ADDENDUM #3

REQUEST FOR QUOTATIONS (RFQ) No. : 1220-040-2022-051

TITLE: RCMP Boiler Replacement

ADDENDUM ISSUE DATE: May 24th, 2022

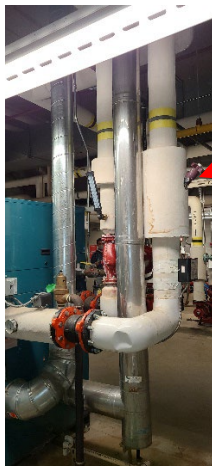
Q.1. Ref. Mechanical spec.; Dwg. #M-2; do Balancing valves and dampers are required. If yes, provide install location on drawing.

A.1. Existing Balancing valves are to be reused and installed on the HWS lines as per below. Modulating flue draft dampers are to be provided and installed per manufacturer's instructions and locations.

Existing Balancing valve to be re-installed
